**ITEM****13 - 19 Boronia Road, GREENACRE****Construction of a Coles Supermarket, Retail Shop and Liquor Outlet Including Associated Basement Carparking and Site Works****S96(2) Amendment:**

**FILE****DA-1149/2009/1 - East Ward****JRPP REFERENCE NO.****2010SYW076****ZONING****3(b) - Business - Other Centres****DATE OF LODGEMENT****11 October 2010****APPLICANT****Coles Group Property Development Ltd****OWNERS****Coles Group Property Developments Ltd****AUTHOR****City Planning and Environment****SUMMARY REPORT**

This current application (DA-1149/2009/1) proposes the following modifications to the application previously approved by the Panel:

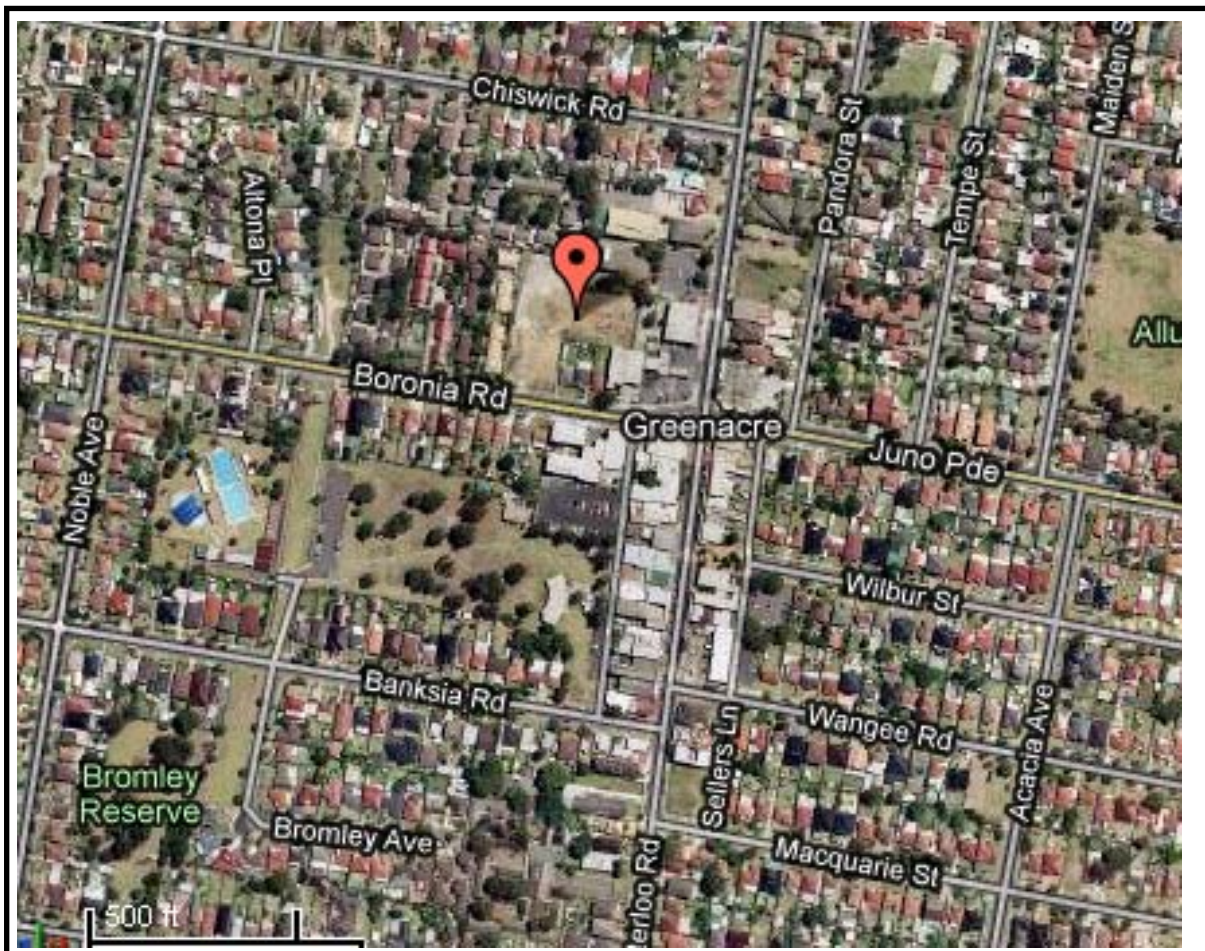
It is recommended that the application be approved subject to the attached modified conditions (see Attachment C), including the following specific amendment to Condition 2(a) in order to address ongoing concerns regarding the design of the north eastern corner of the building:

The subject application also includes some modifications to the external appearance of the north east corner of the development, in an attempt to address the requirements of Condition 2(a). The glazed screens on the northern boundary have been replaced by 2.0m high panel walls similar to the full height panels that make up the remainder of the northern, eastern and western elevations, however the access to this external area remains from within the building, and the signage and different-coloured panels also remain. It is these elements which are considered likely to create the misapprehension of an entry point existing in this location, and as such, it is considered appropriate to amend Condition 2(a) so as to ensure appropriate changes are made.

- a) Amended plans are to be submitted which provide for the deletion of the *external courtyard* at the north-eastern corner of the proposed development and the external appearance of the development in the area of the *external courtyard* access point on the northern and eastern elevations is to match the remainder of the northern and eastern facades. *In particular, no signage is permitted in this location, and the colours, articulation and finishes of the wall panels in this location shall all be consistent, with no "feature" colours incorporated.*
